# Product Change Notification

| <b>Date Issued :</b>                                                                                                                | July 17, 2026                                                                                                                                                                | <b>PCN Number :</b> | 518475 |
| <b>PCN Subcategory:</b>                                                                                                             | PCQC - Label Change                                                                                                                                                          |                     |        |

# General Market ID + Marking Updates

# Molex GM Historical ID + Marking

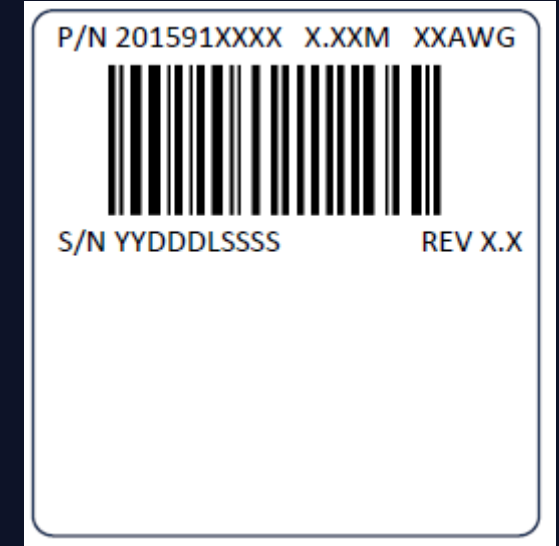
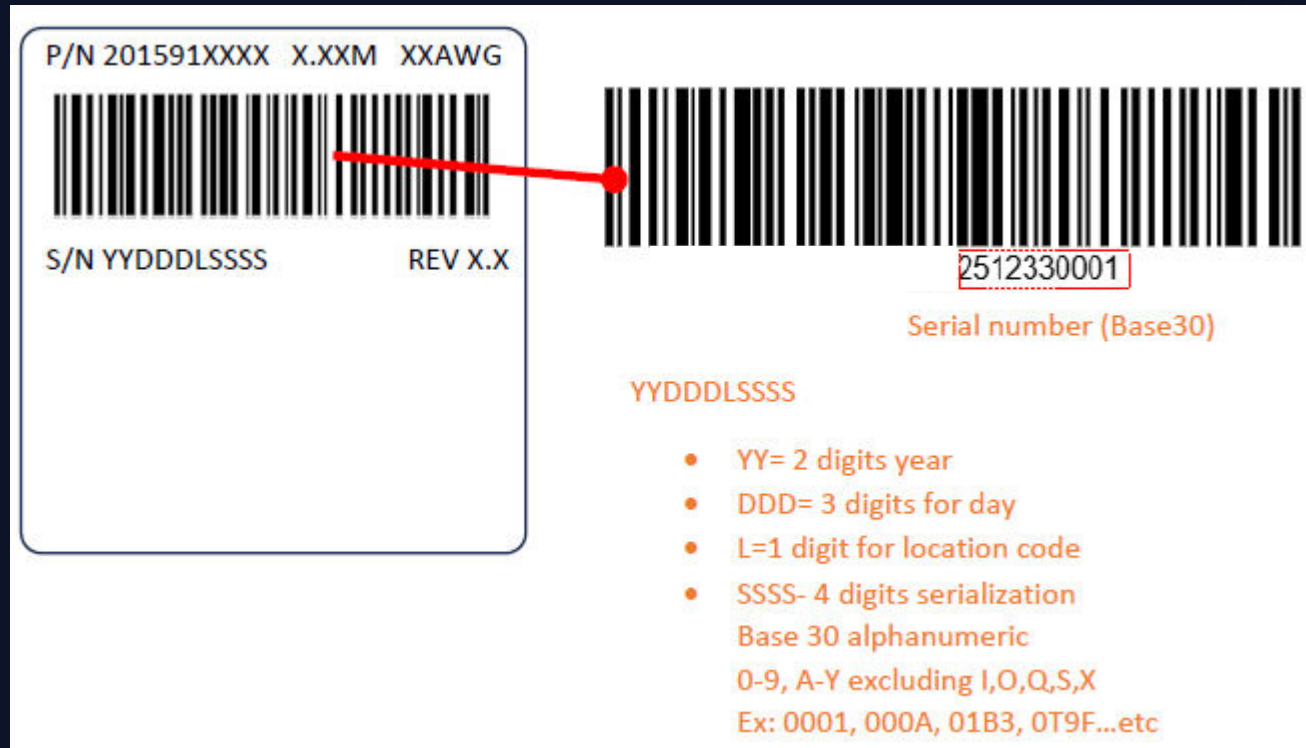
- Serial Number Format
  - YDDLSSSS or YYDDLSSSS
  - YY = 2 digit year
  - DDD = 3 digit day of year
  - L = 1 digit location code
  - SSSS = 4-digit base10 serialization 0000-9999
- Serial Number Uniqueness
  - Serial number is unique to the part number
- Barcode Format
  - Serial number only e.g. YYDDLSSSS

- Serial Number Format + Serial Uniqueness
  - Daily limit of 10,000 serial numbers
    - SSSS = 4-digit base10 serialization 0000-9999 limits the total number of pieces per day to 10,000
  - Daily limit forced us to configure serialization to be unique to the part number
- Barcode Format
  - Barcode content only contained the serial number; this caused confusion with customers buying multiple Molex part numbers
  - Some customer systems cannot recognize per-part number uniqueness; their systems require the part number in the barcode to verify no duplicates within a part number
  - Some customer systems require the part number in the barcode as part of their inventory control system

- Update from Base10 -> Base30 Serialization
  - Base30 serialization allows us to support up to 810,000 unique serial numbers per day; this will allow us to group ALL part numbers together to ensure no duplicates across part numbers
